# City of Santa Fe, New Mexico

# memo

2026-012103-HDRB, 1121 and 1123 Paseo de Peralta, Downtown & Eastside Historic District, contributing, Architectural Alliance, agent for KCS Oil and Gas LLC, owner, requests status review and primary façade designation, if applicable, for two non-residential structures, yard walls, and a shed.

Figure 3: 1121 Paseo de Peralta footprint growth.

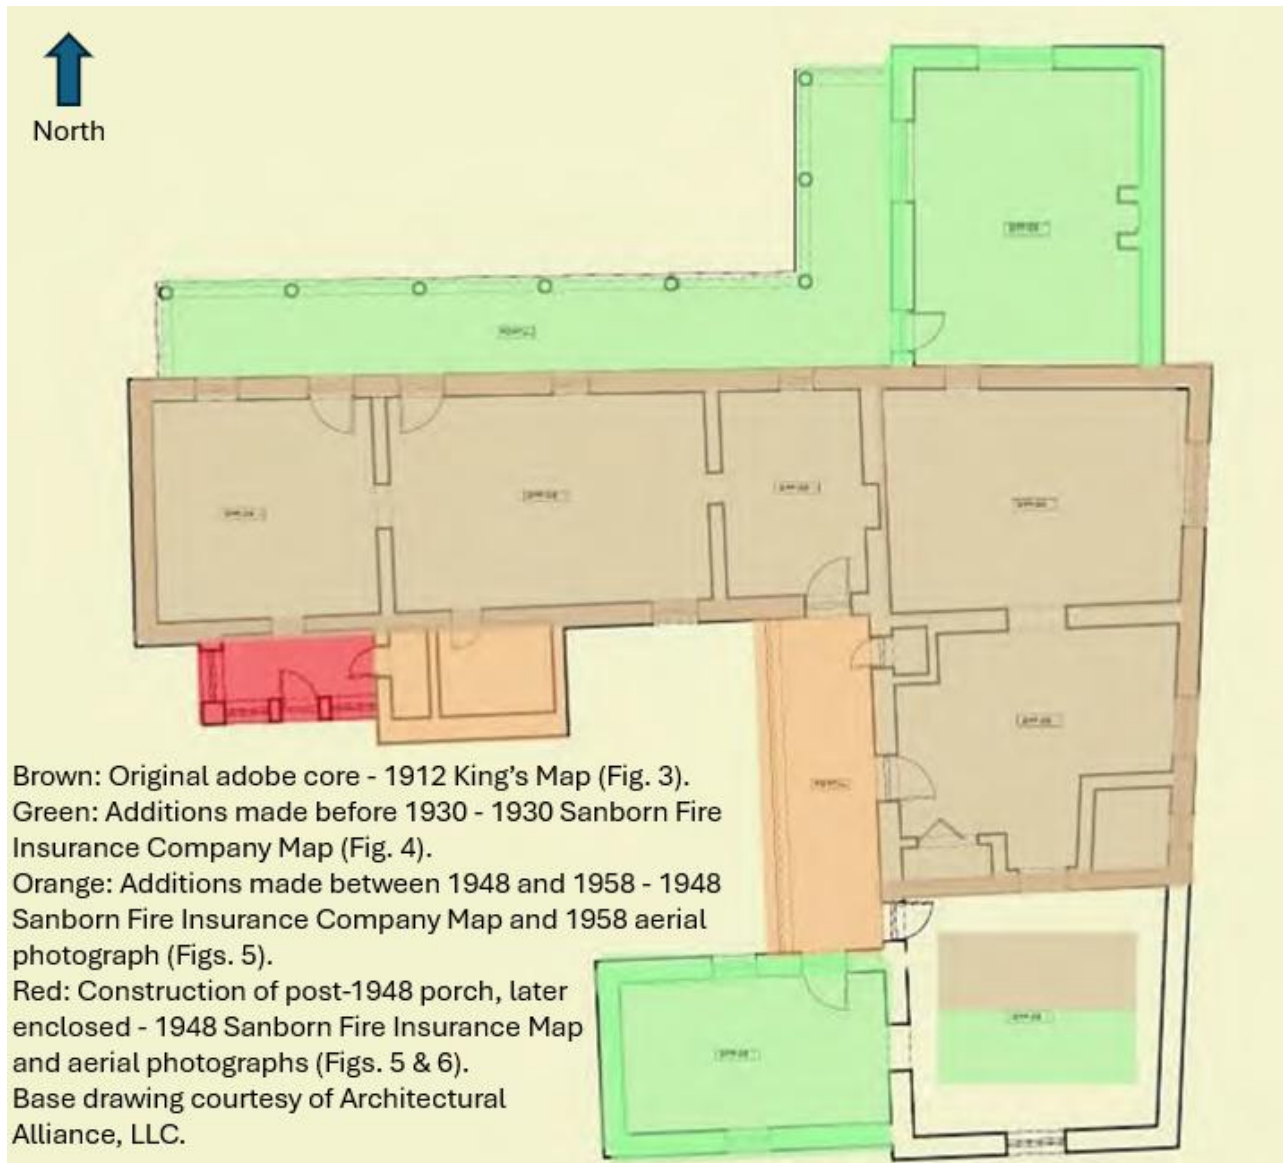
The building at 1121 Paseo de Peralta was constructed of adobe in an “L” shape in 1912. The original structure had no portals or projecting exterior features. An “L” shaped portal was constructed on the north façade after 1912. An adobe addition on the east end of the north elevation was constructed after 1930. The portal is supported by wood posts and has corbels and vigas with rough-sawn board decking on the interior. Several supports on the north elevation have been stuccoed. The connecting plate for the portal partially obscures a window opening on the southeast corner. The west wall of the building has no fenestrations. The southwest corner of the south elevation includes a post-1958 addition that has a lower roof, which may be an earlier enclosed porch area, a lower pony wall topped with wood windows, and an older raised-panel Dutch door. Going east, the south elevation transitions to a pre-1958 addition characterized by a rounded parapet and a line of sawn-off vigas. This leads to a west-facing portal, which was introduced between 1948 and 1958. As the building turns south, it incorporates a low, rectangular shed-roofed section that was constructed between 1912 and 1930. The wall of this section has a slight projection near the roofline, which accommodates a chimney. The stepped stucco chimney thickens as it rises above the parapet with a metal stovepipe flue at the top. As the wall proceeds eastward, it increases in height, and the wall plane returns to what may be the original building or an apartment constructed before 1930. Two non-historic chimneys rise above the parapet on the west. The east elevation is limited to fenestration of a mix of older wood sash windows; most are set close to the ground. The windows are obscured by brush, one is partially infilled with stucco, and one window has only one part of the sash elements remaining. The east post-1912 projection holds a stuccoed chimney.

1121 Paseo de Peralta was constructed and expanded from 1912 through 1958. The entire structure is historic and is currently listed as contributing. Staff finds that the historic integrity of the structure is retained, and the structure should remain a contributing structure. Staff further finds that the north elevation and the west elevation, including the portal, clearly convey the character of the structure. The recommended primary façade should exclude the non-historic doors and windows and other materials or design elements that detract from the historic character.

The low walls at the property show that the building was once a residence and help to define its character and charm; therefore, staff would recommend that they be stasued as contributing.

Figure 4: 1123 Paseo de Peralta footprint growth

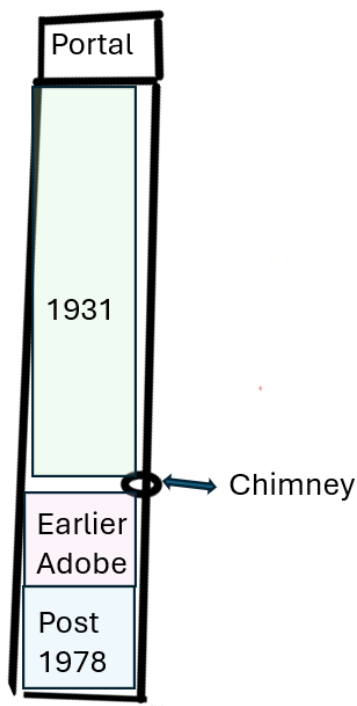
The building at 1123 Paseo de Peralta was constructed in 1931 on the west side of the property. It appears to have either replaced or incorporated an older adobe outbuilding. The north elevation front porch holds a unique mushroom-shaped opening reflecting a vernacular expression of Mission Revival Design. Either side of the portal has keyhole-shaped openings, which are a form rooted in Mission Revival style. The porch interior holds a plastered ceiling and a concrete floor.

1123 Paseo de Peralta – contributing with the north, including the portal as primary and the portion of the east elevation reflecting the 1931 construction phase, excluding the non-historic doors and windows, along with other material or designs that detract from the historic character of these elevations.

The yard walls connected to the southeast corner of the structure at 1123 Paseo de Peralta do not match the historic character of the small compound. Therefore, the staff recommends that they be designated as non-contributing.

Figure 8: Façade Diagram

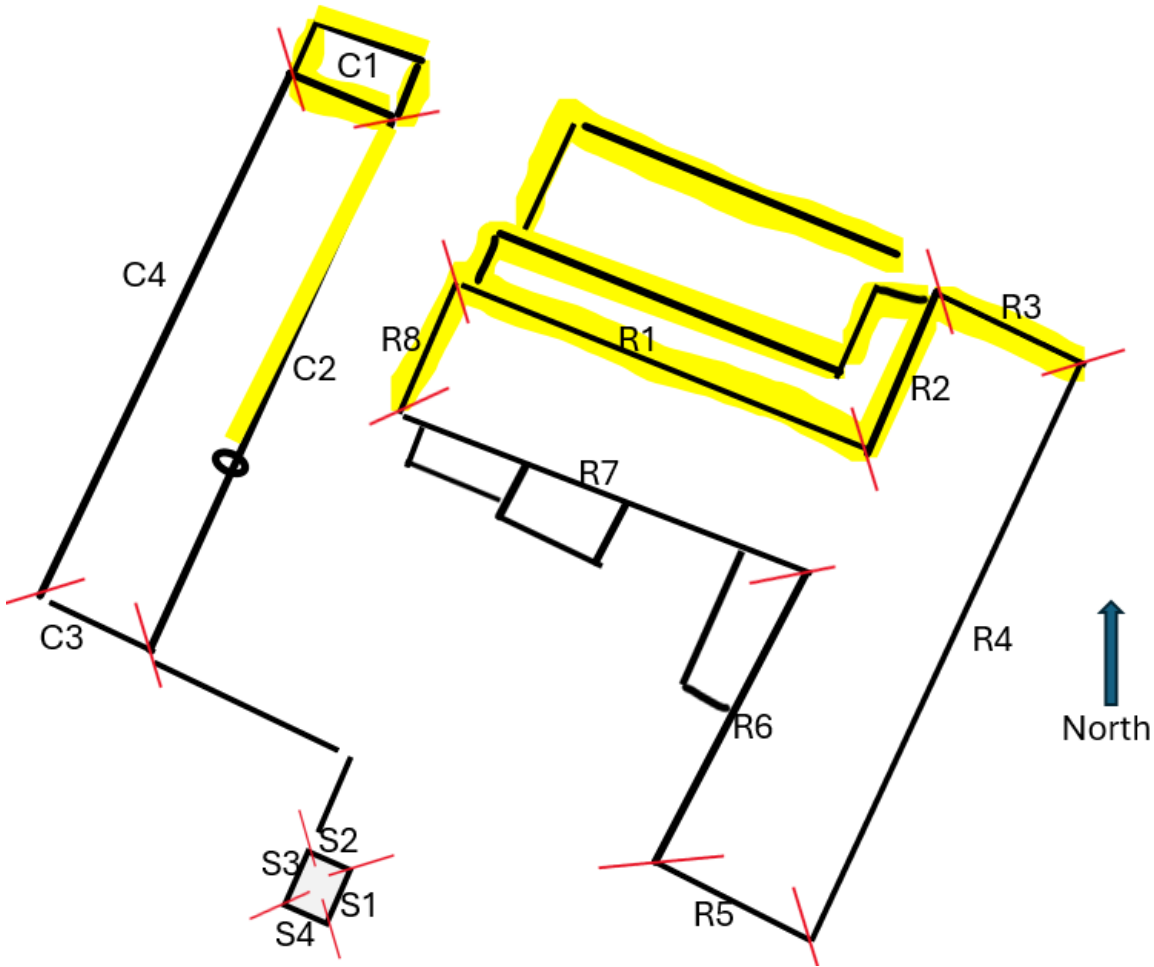
Staff recommends the historic status of the 1121 Paseo de Peralta structure be maintained as contributing with the north and west facades, including the portal, pony walls, and excluding the non-historic windows and doors as the primary façade (see Figure 8 Façade Diagram, R1, R2, R3, and R8), and the yard walls along the street be designated as contributing. Staff recommends the historic status of the 1123 Paseo de Peralta structure be maintained as contributing with the north facade including the portal and the east of the 1931 addition up to the chimney feature and excluding the non-historic windows and doors as the primary façade (C1 and C2), and the shed and yard walls at the rear of the property be designated as non-contributing per 14-04.06(C) Designation of Significant, Contributing or Noncontributing Status Within Historic Districts.
